Various DNR Properties – ADA Compliant Playground Improvements
IDOA Project #E010-017A

Addendum #3 – January 3, 2018

DRAWING #:
SD103

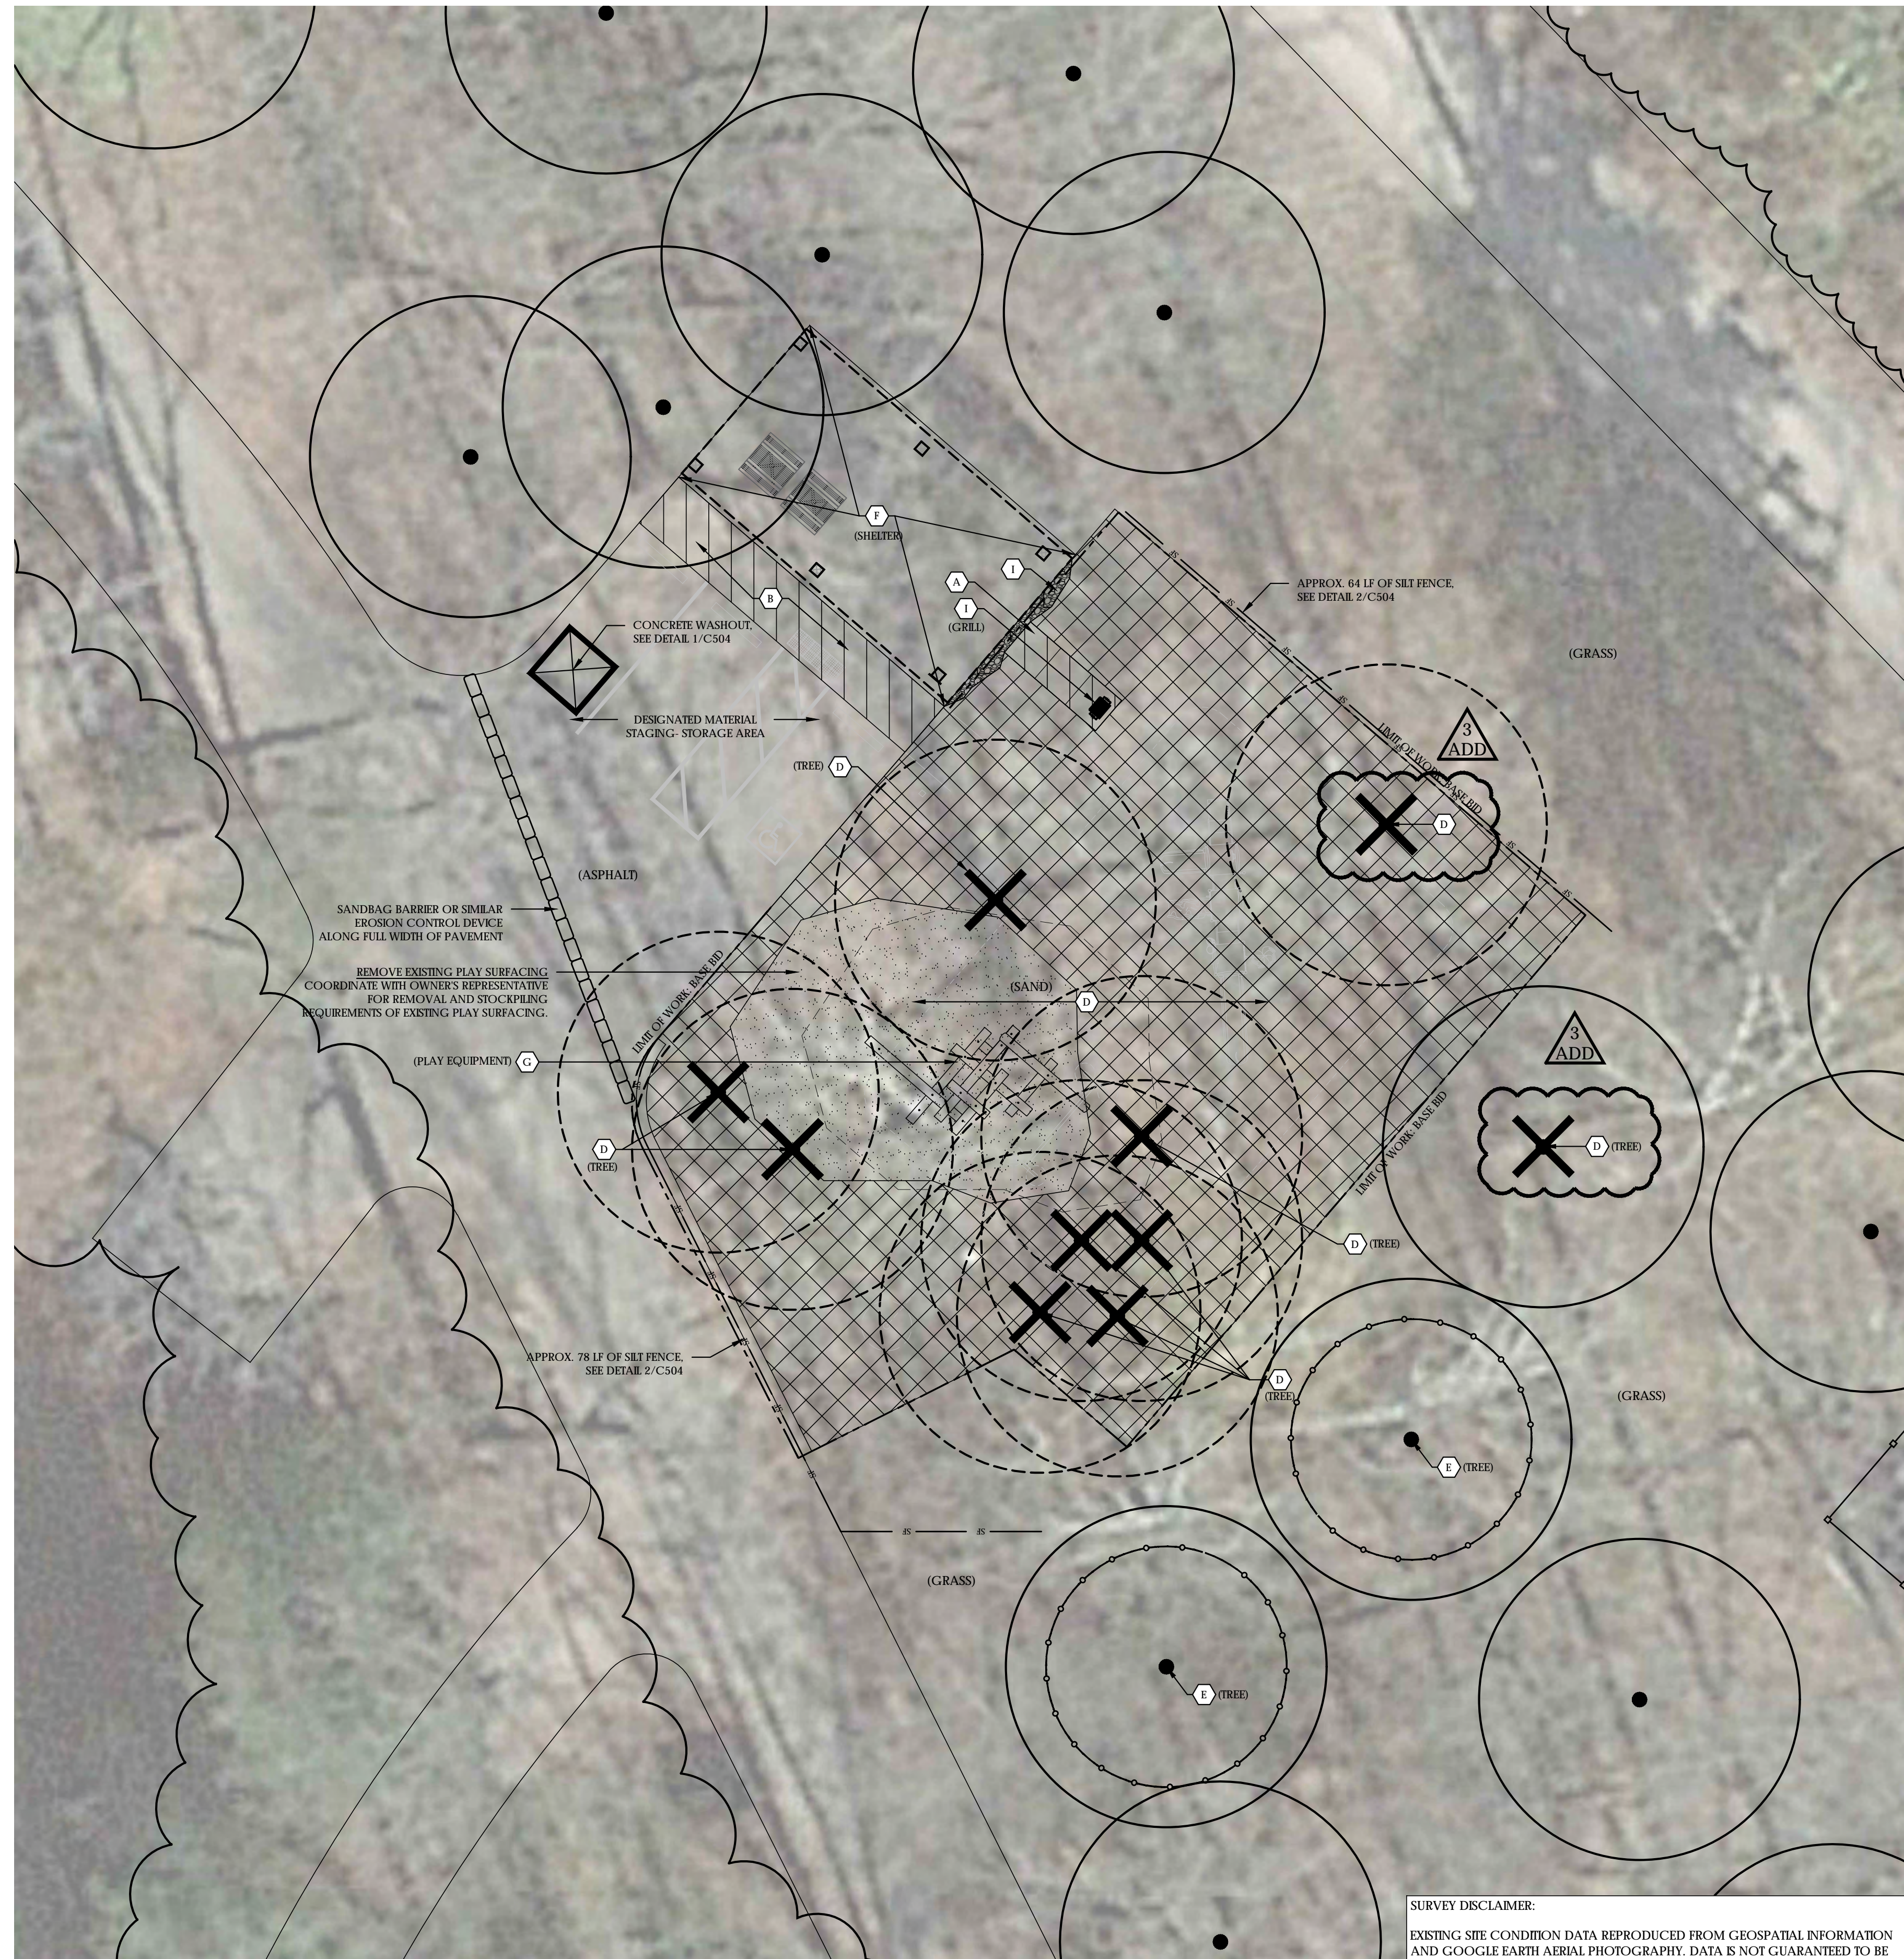
QUESTION #13: *At Green-Sullivan State Forest, the layout shown by drawings SD103, and SD203 appears to represent the positions of the existing trees inaccurately. The actual tree positions relative to the shelter structure are different than shown on the plans. Additional tree removals of significant size would be required to accommodate the playground shown.*

- ITEM #1:** REVISE sheet SD103. Revise keynote “E” on the most northeasterly existing tree within proposed playground footprint to be keynote “D”.

ANSWER #13: See Revision to Drawings, sheet SD103. Contractor shall remove conflicting trees including grubbing of stump and roots as necessary to install the work complete and in full conformance to the Contract Documents.

DRAWING NAME: **PLAN GROUP A CHAIN O' LAKES STATE PARK LAYOUT PLAN**
REDA Project #: 161448
Date: 11/28/2017
Drawn by: KK
Reviewed by: CK
DRAWING #:
SD201

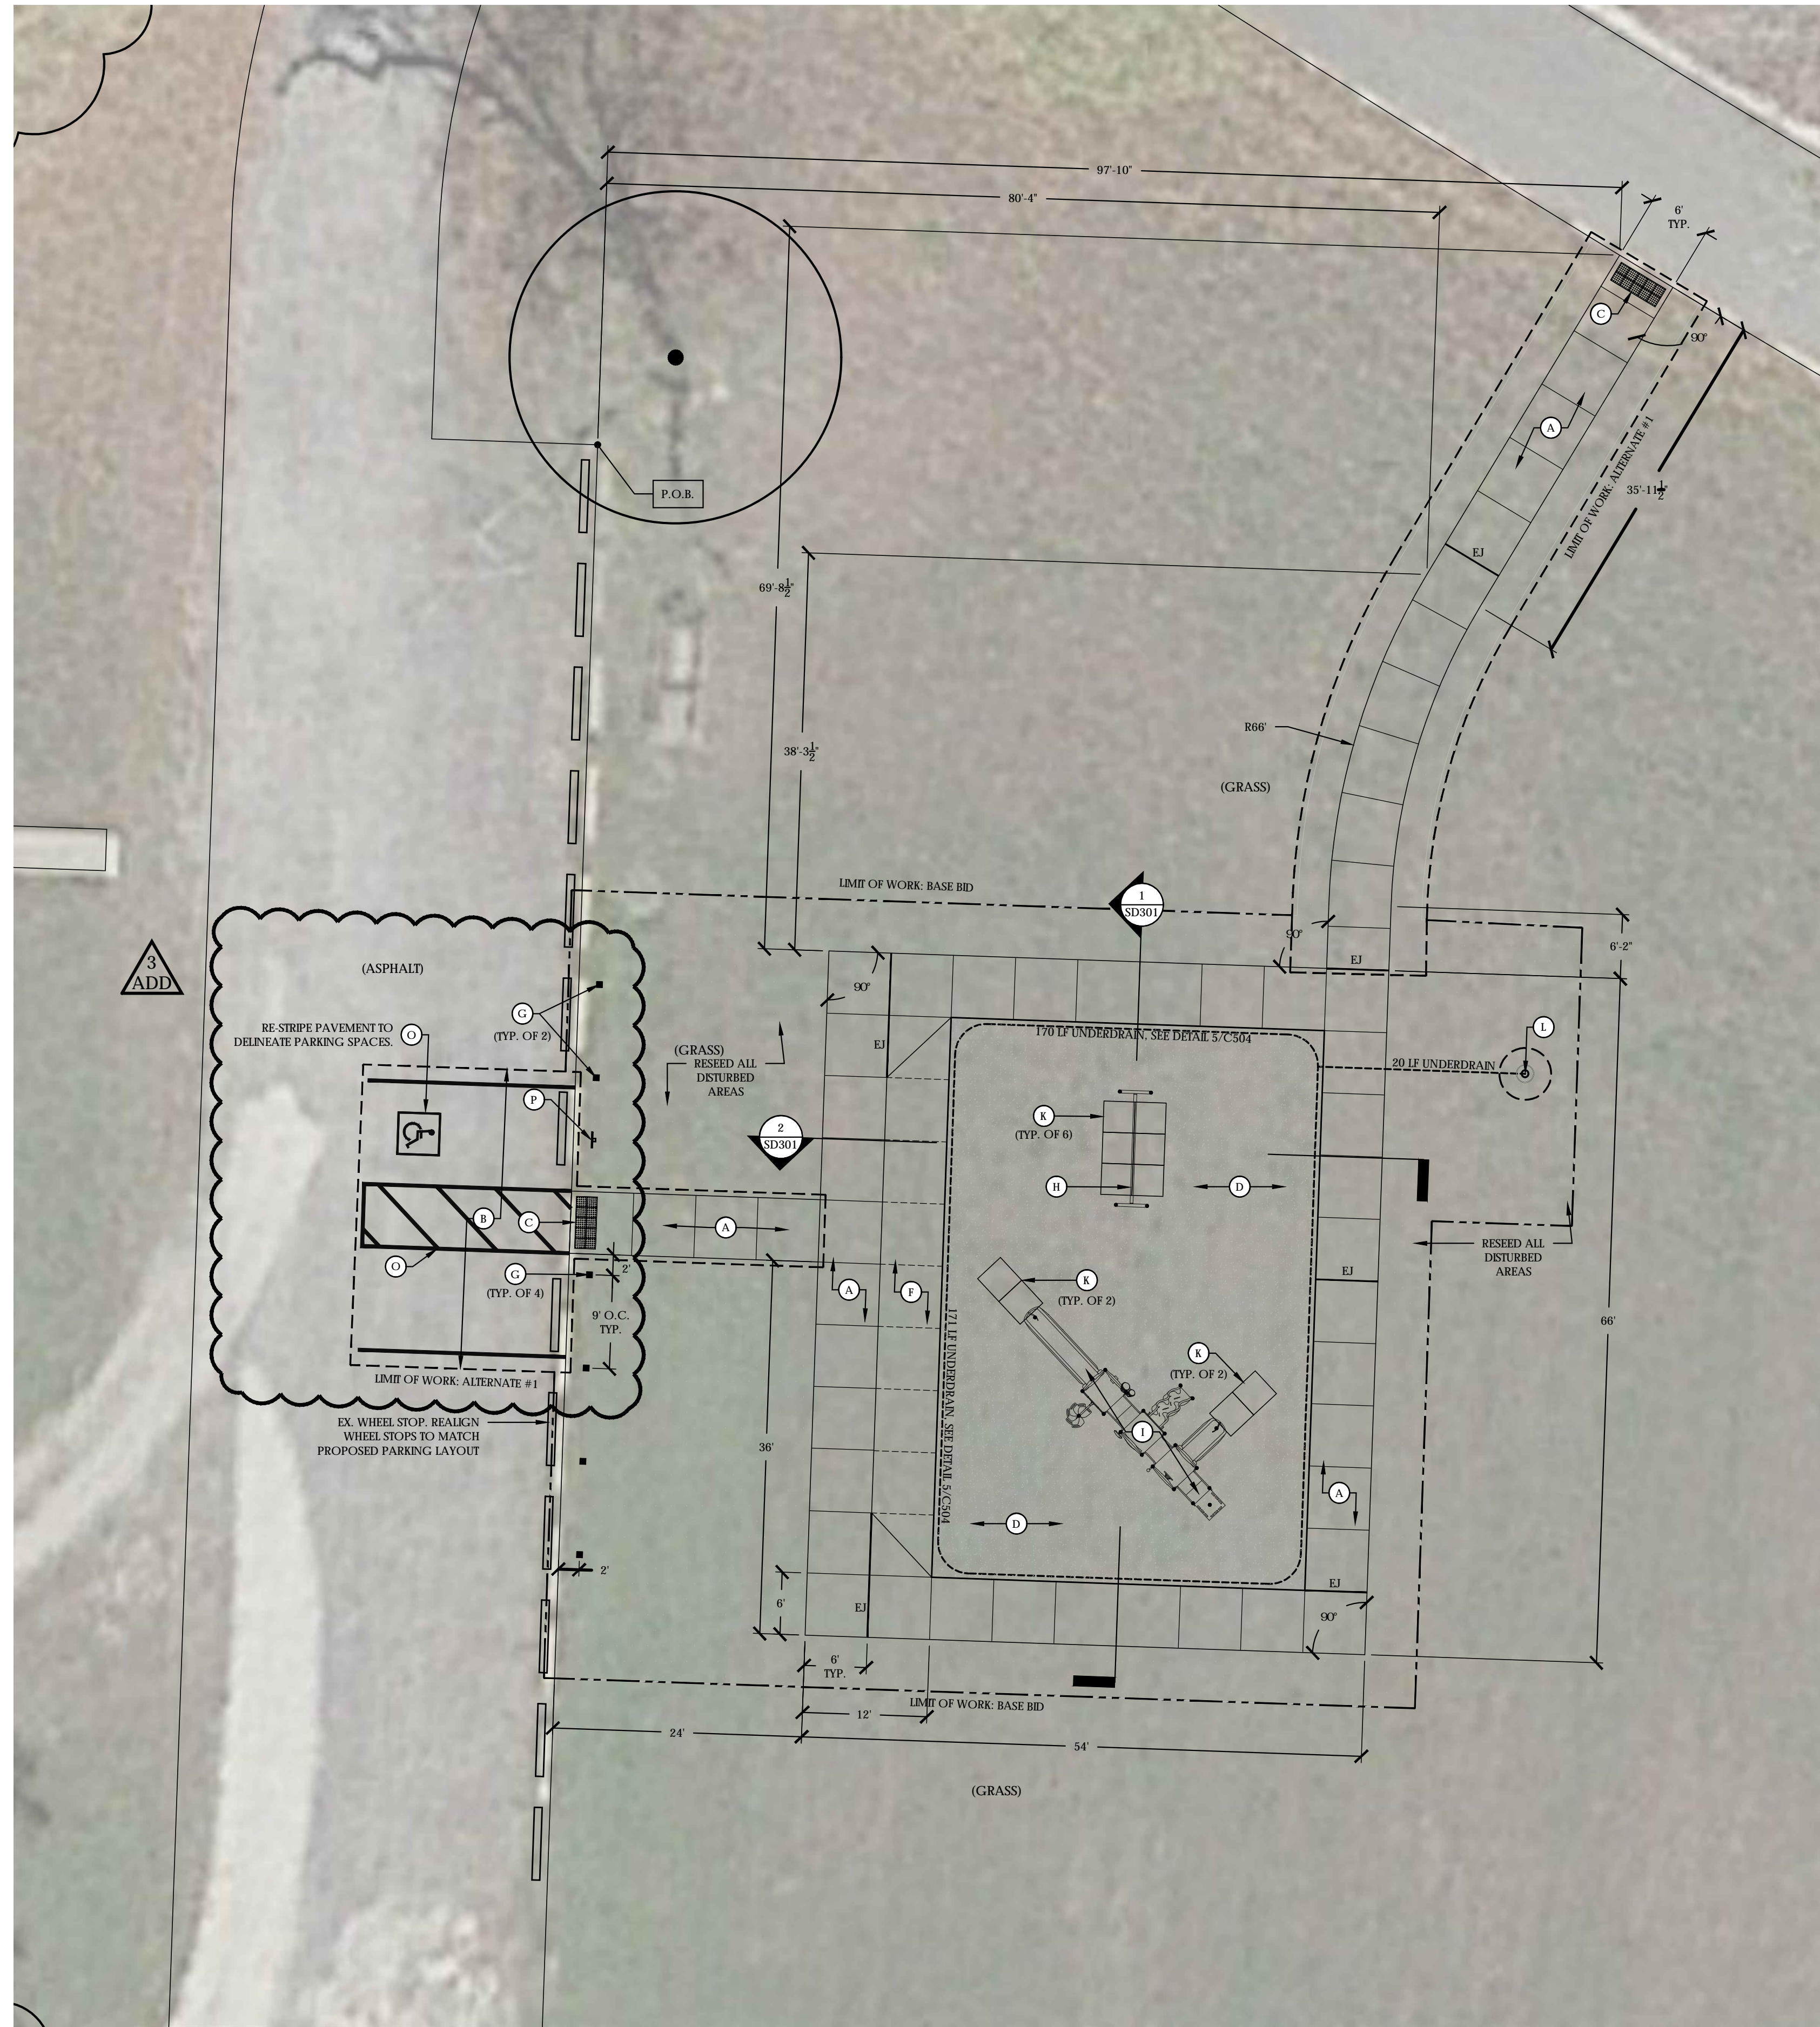
- ITEM #2:** REVISE sheet SD201. Revise keynote “C” to keynote “G” for bollards at perimeter of existing drive. Revise keynote “K” to keynote “M” for both western drainage outfalls.

DRAWING NAME: **PLAN GROUP A SHAKAMAK STATE PARK LAYOUT PLAN**
REA Project #: 161448
Date: 11/28/2017
Drawn by: KK
Reviewed by: CK
DRAWING #:
SD208

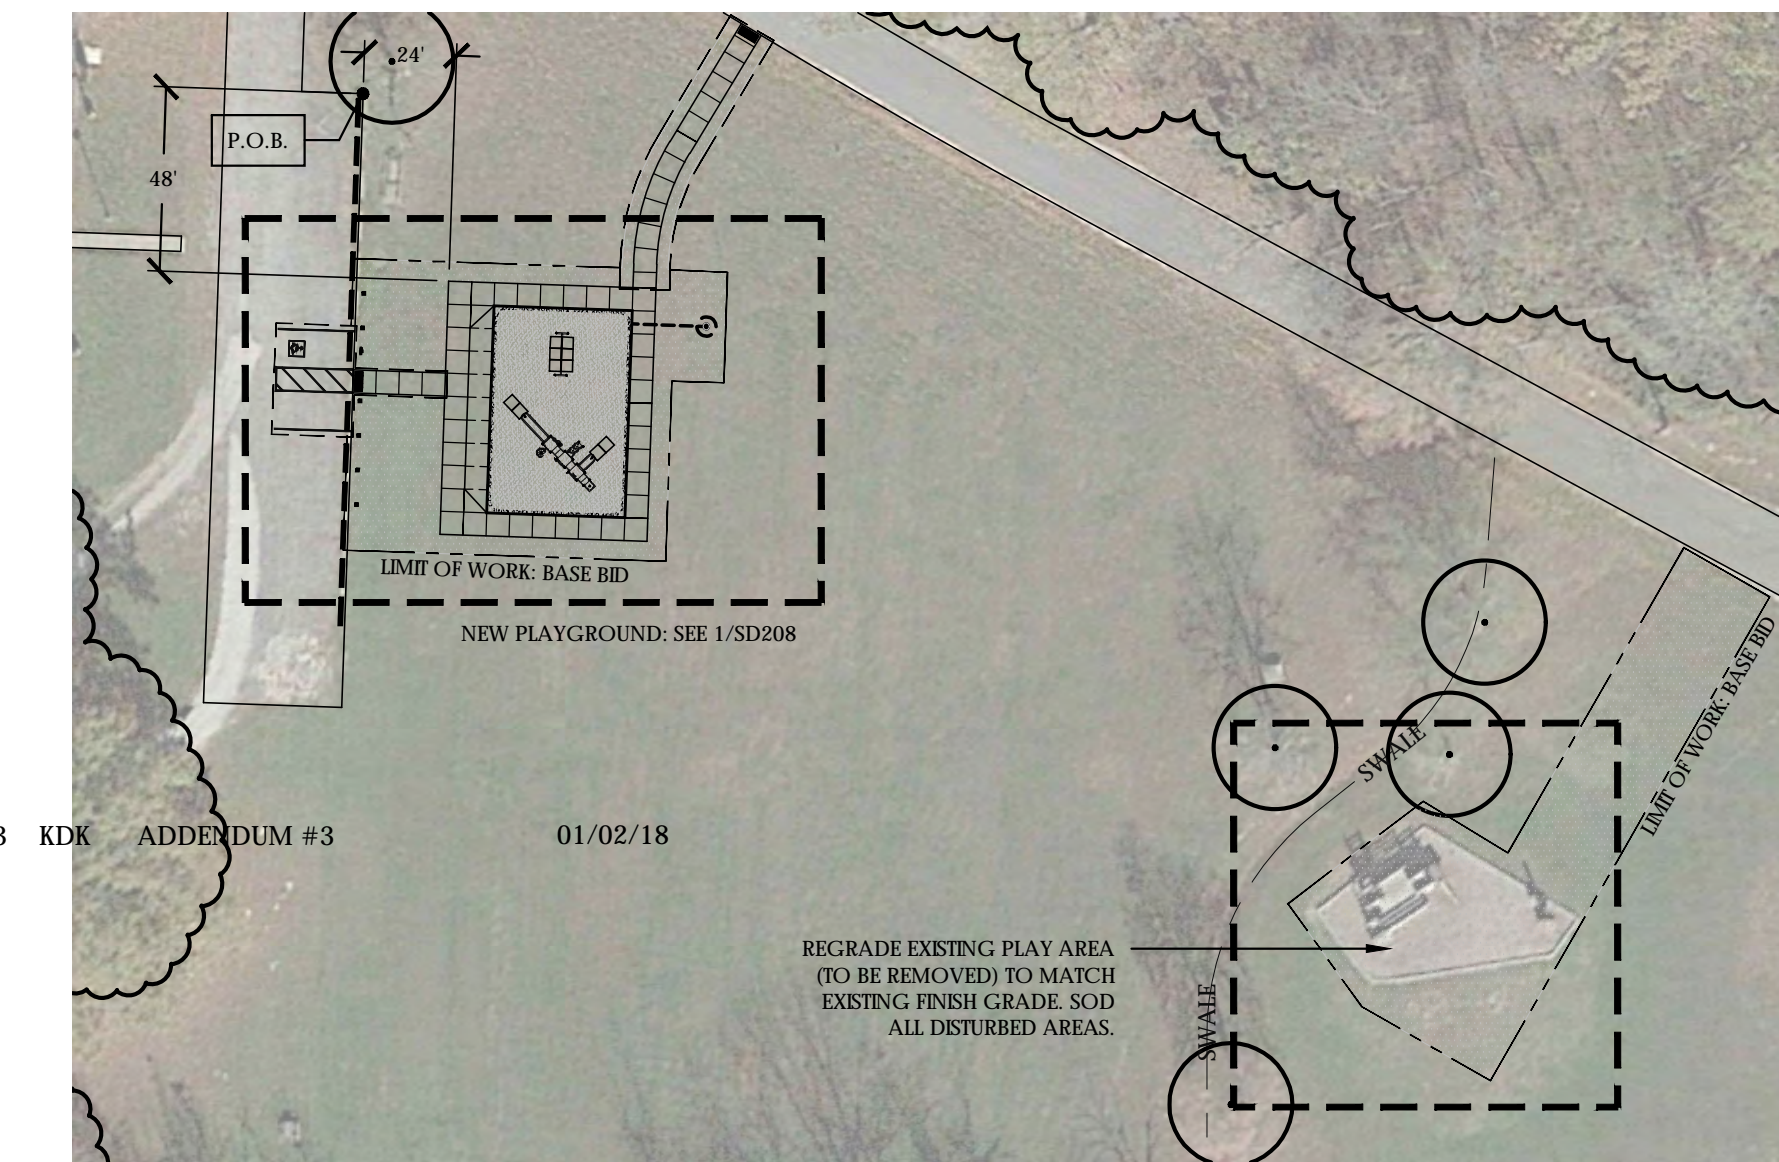
QUESTION #4: *At Shakamak State Park, Sheet SD208 calls for re-stripping of pavement in an area that is not paved. The area is actually a layer of loose grave*

spread over an old layer of oil and gravel. The drawings do not call for new pavement. Will new pavement be required?

ANSWER #4: Yes, Bidding Contractor shall provide new concrete pavement for extent of proposed parking stalls as detailed per 3/SD501.
